County of Santa Clara
Airport Land Use Commission

DATE: December 16, 2020, Regular Meeting

AGENDA

County of Santa Clara
Department of Planning and Development

Figure 3. Land Use/Noise Contours

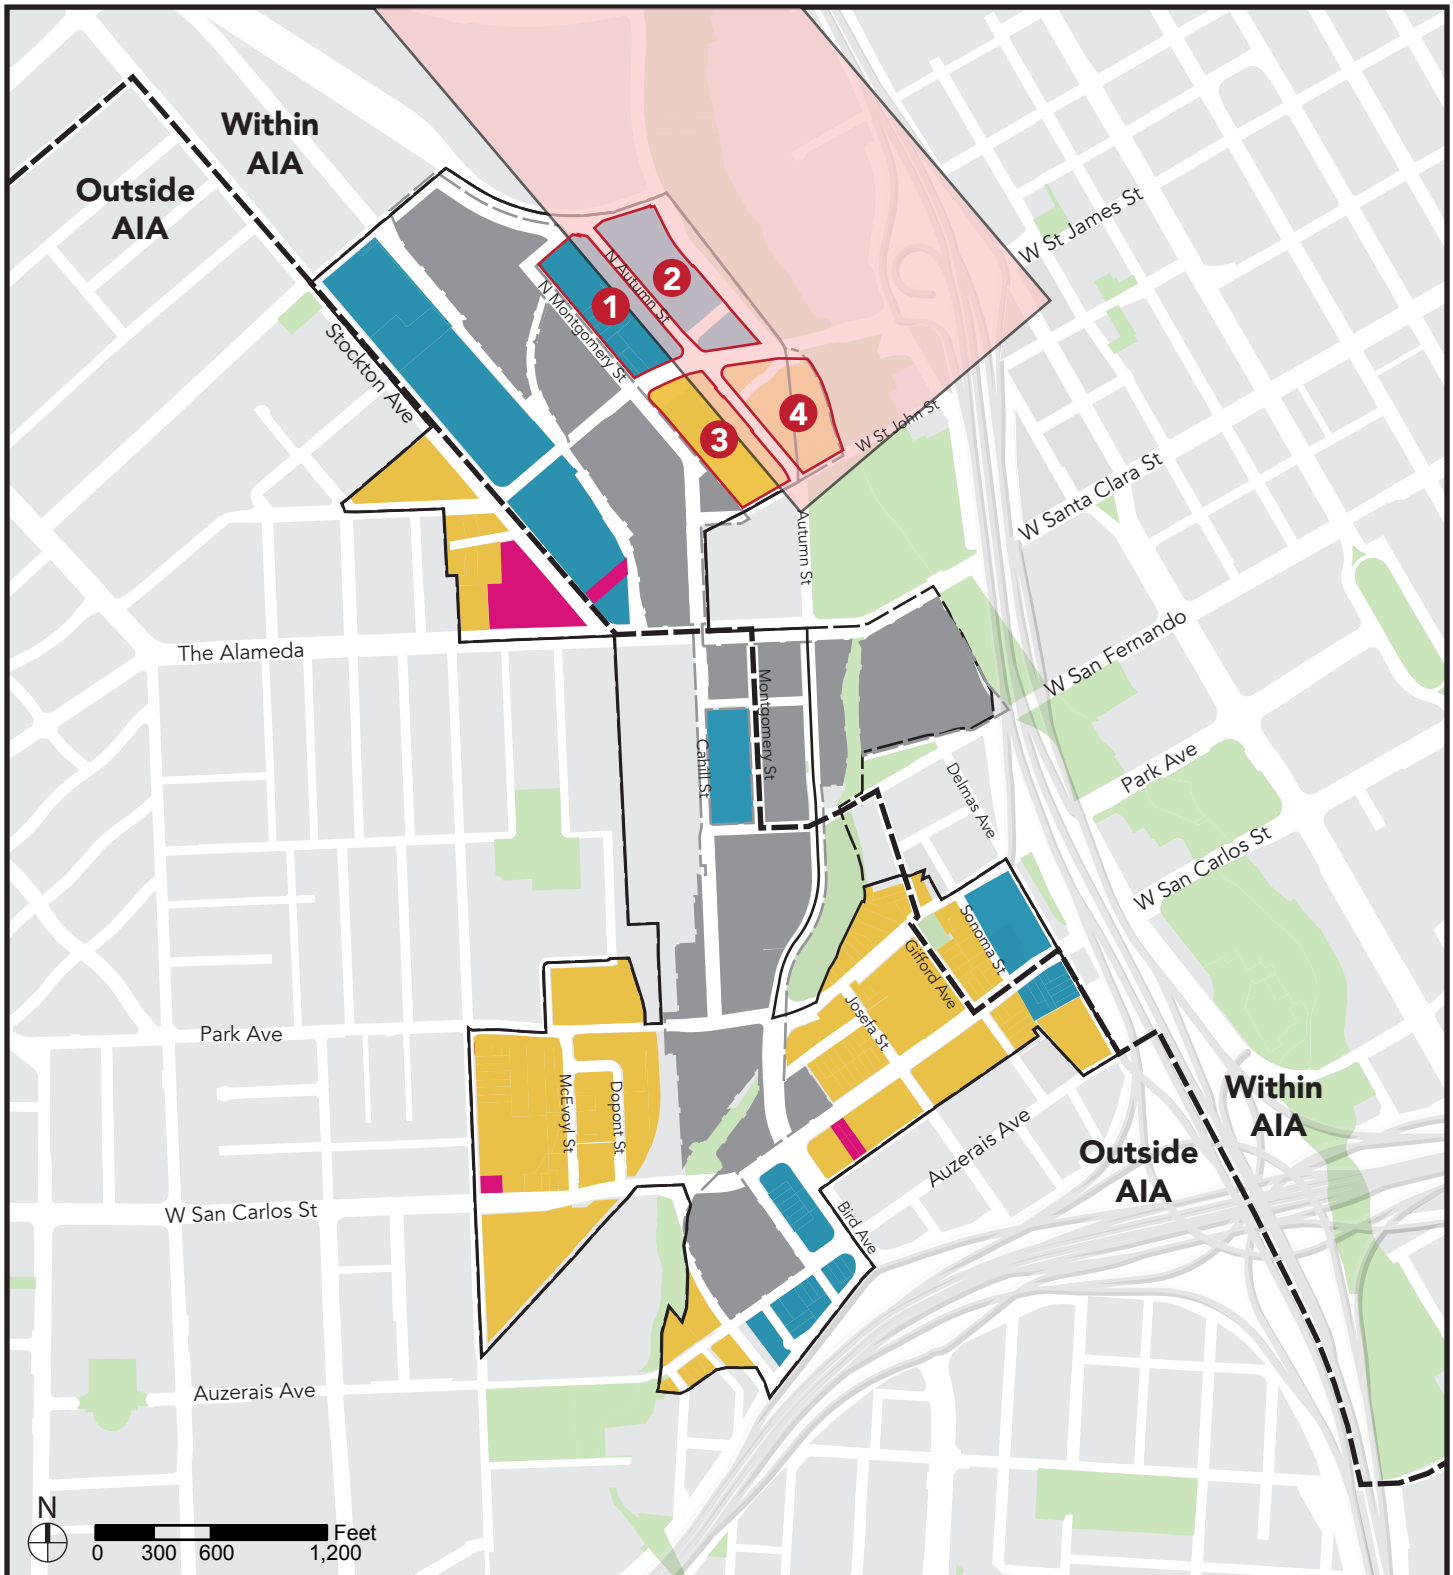
As seen on Figure 3 of the referral "Land Use/ Noise Contours", the Specific Plan area is located between the 60 and 70 dBA CNEL noise contours and would allow Employment Commercial, residential and retail uses within these CNEL noise contours.

Figure 4. Land Use/Safety Zone

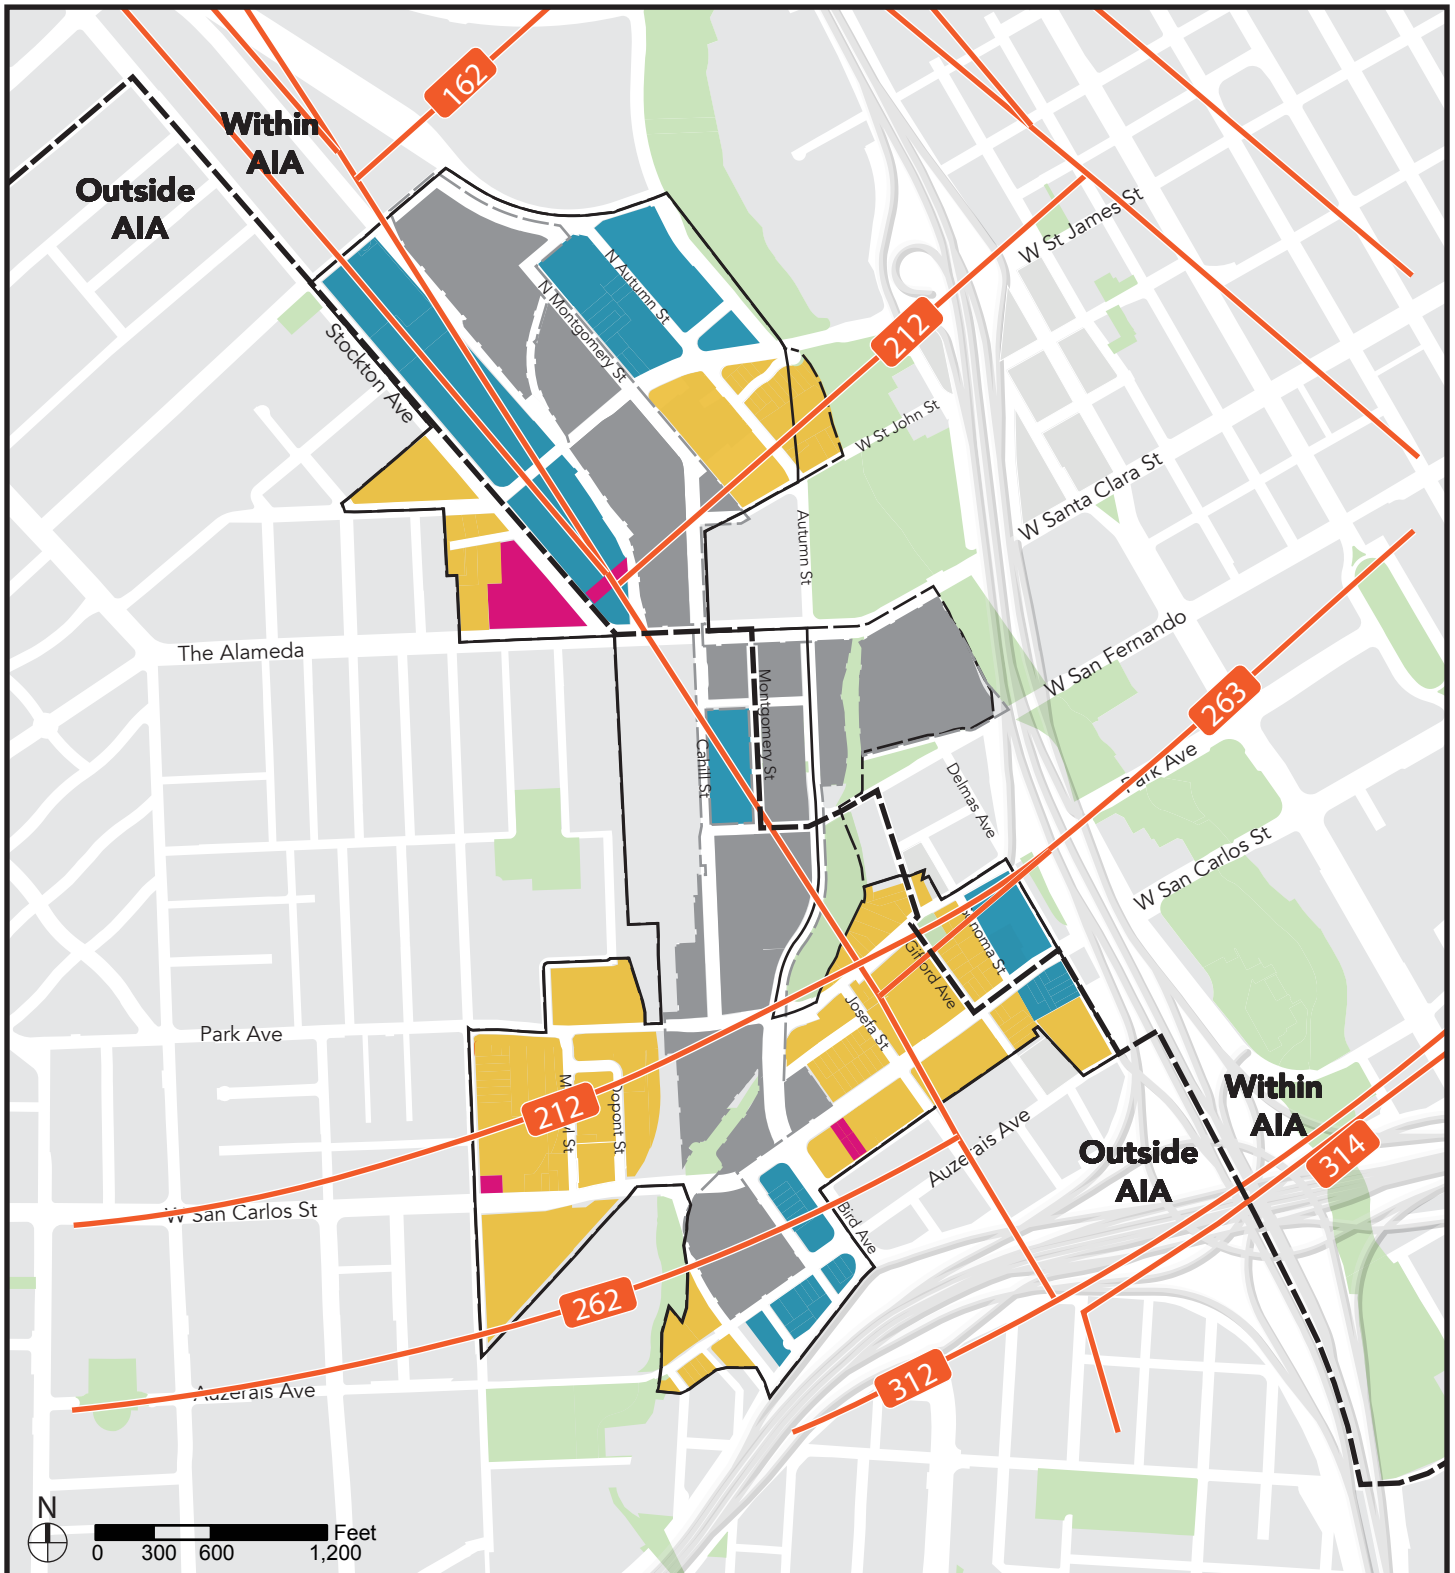
As can be seen on Figure 4 of the referral “Land Use / Safety”, four plan areas lie within the Outer Safety Zone (OSZ) for SJC. Both Downtown and Downtown Commercial Land Uses, which include residential and retail development. The Downtown land use designation would

Figure 5. Existing Heights (OEI)

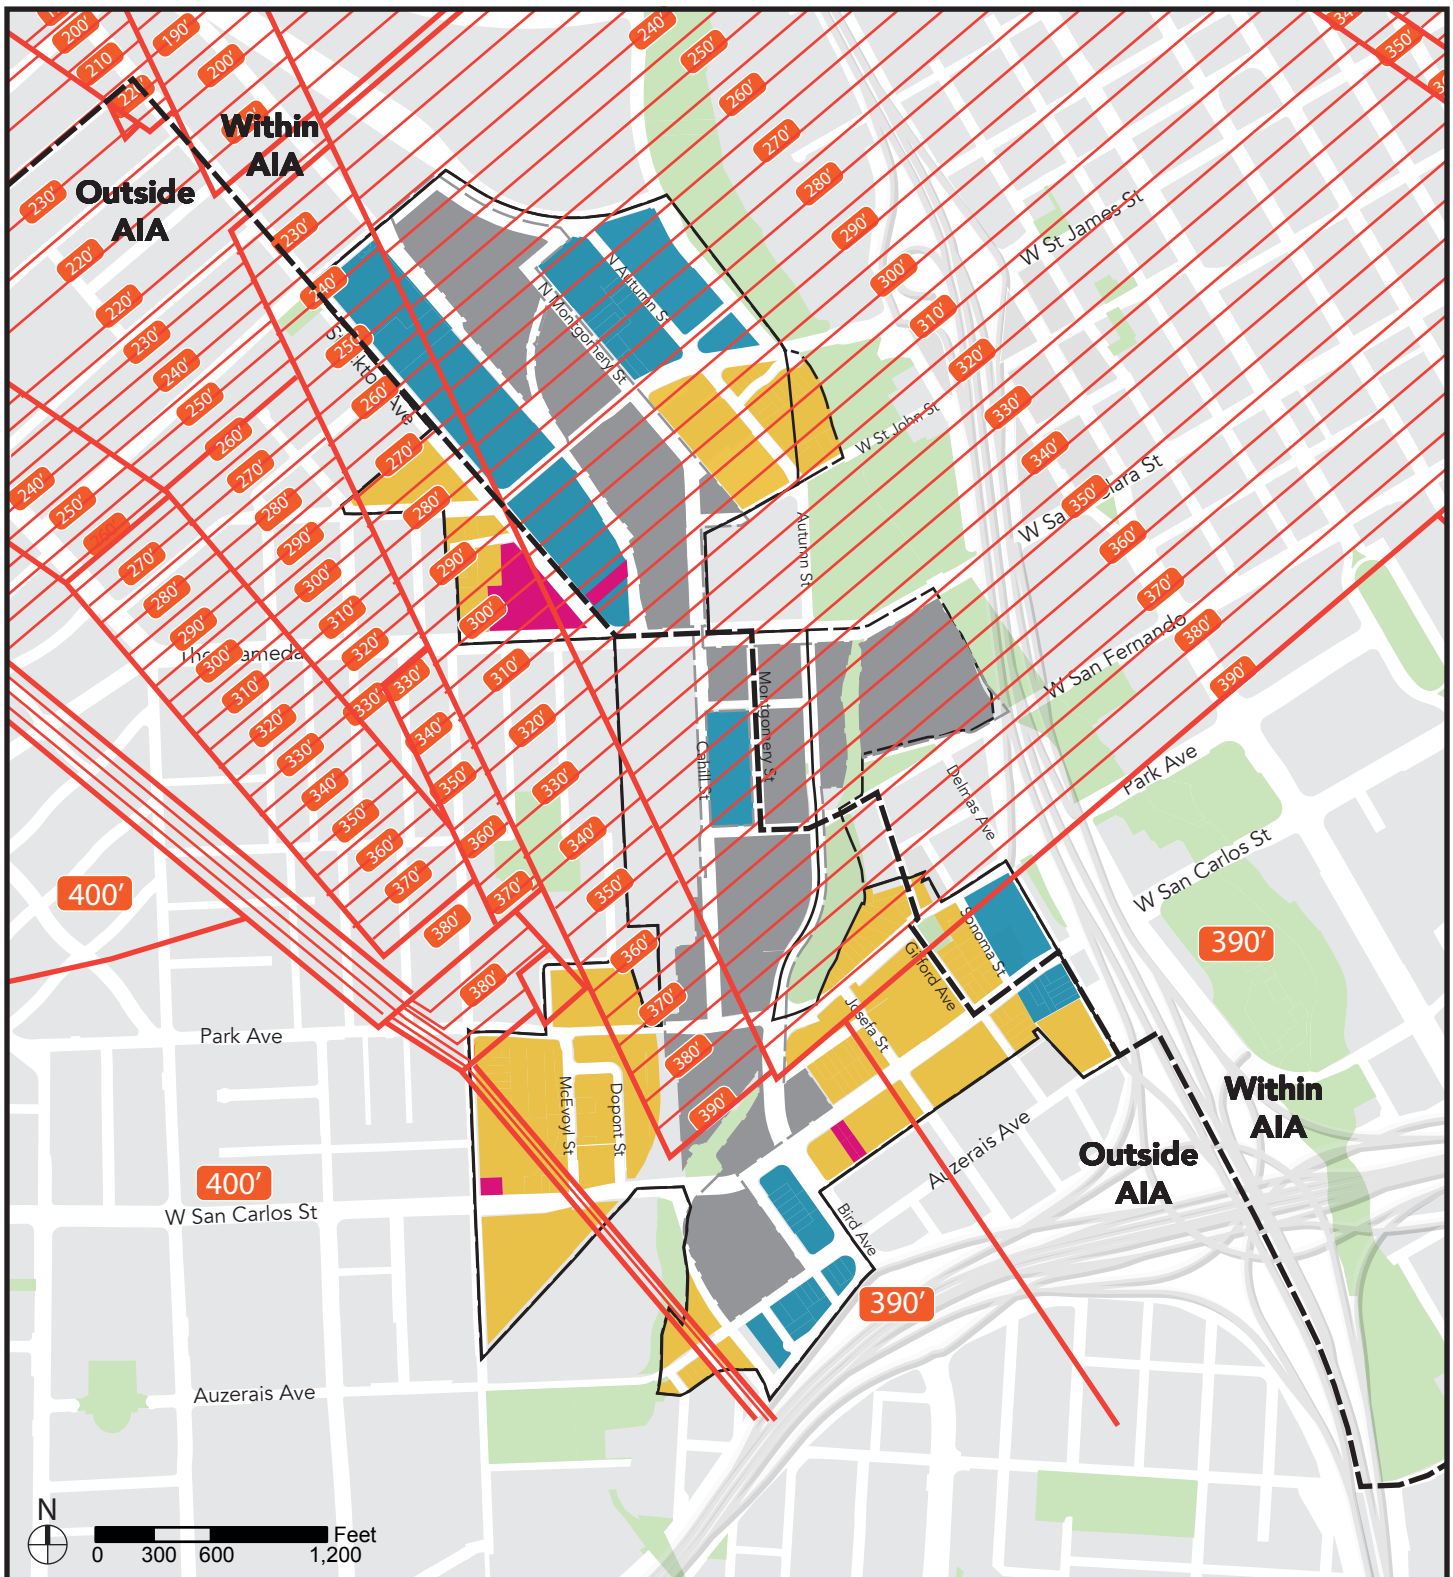
Figure 5 of the referral is titled “existing heights / OEI”, but is actually the FAA FAR Part 77 surfaces. Figure 6 shows the Terminal Instrument Procedures (TERPS) surfaces. And Figure 7 shows the ground elevations. In June of 2020, the San Jose City Council adopted TERPS as the height limitation surfaces for the area south of SJC. Because there was no associated projects, there was no required referral to the ALUC for consideration. However, City staff did attend an ALUC meeting in March of 2020 as a courtesy to inform them of the changes.

Figure 9. Proposed Maximum Building Heights

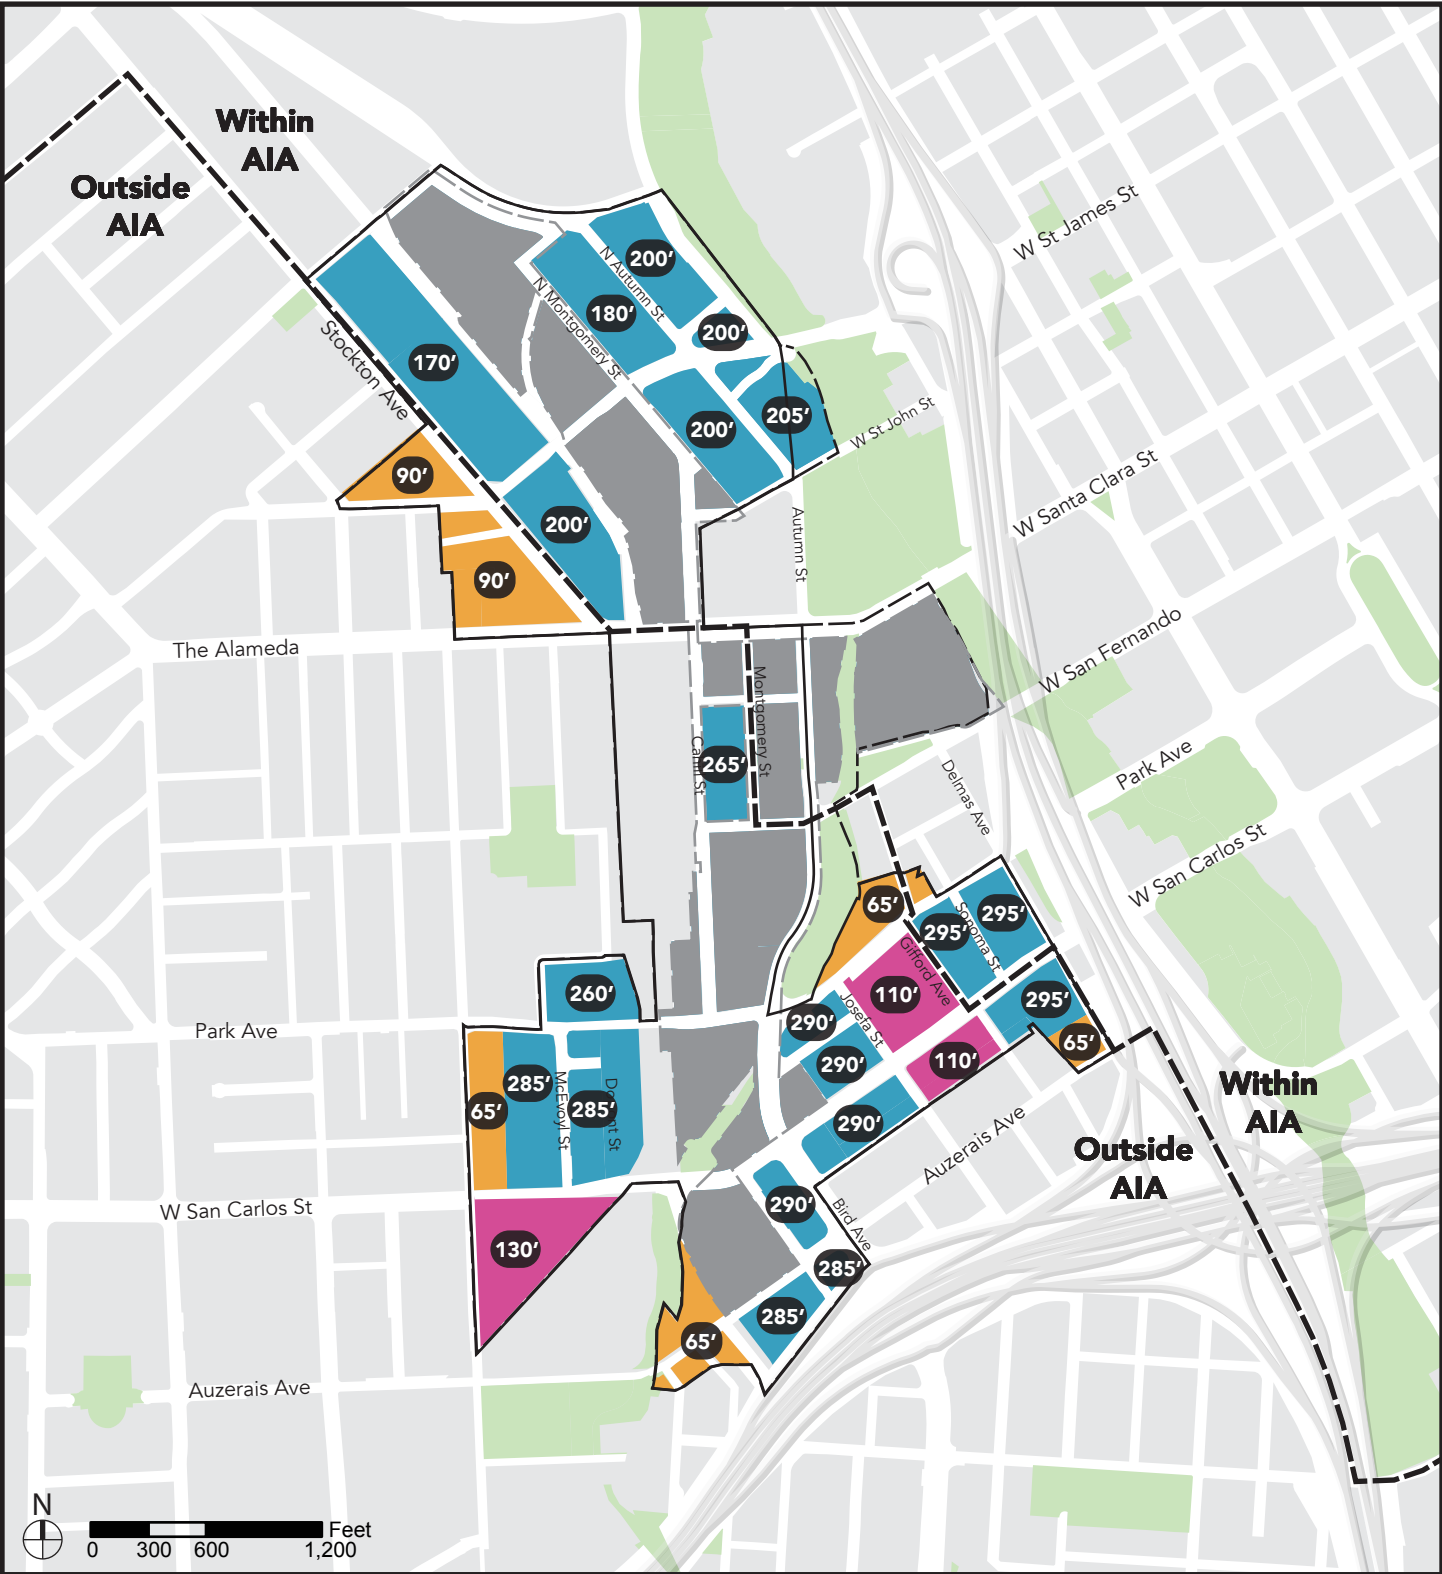
Figure 9 shows the proposed heights in the DSAP Specific Plan amendment. For comparison, Figure 8 shows the existing heights allowed in the 2014 DSAP.

Figure 9 of the referral shows building heights up to 295 feet tall allowed within the Station Area Plan amendment. All proposed heights proposed in the DSAP amendment would exceed the allowed heights (FAR Part 77 Surfaces) in the SJC CLUP
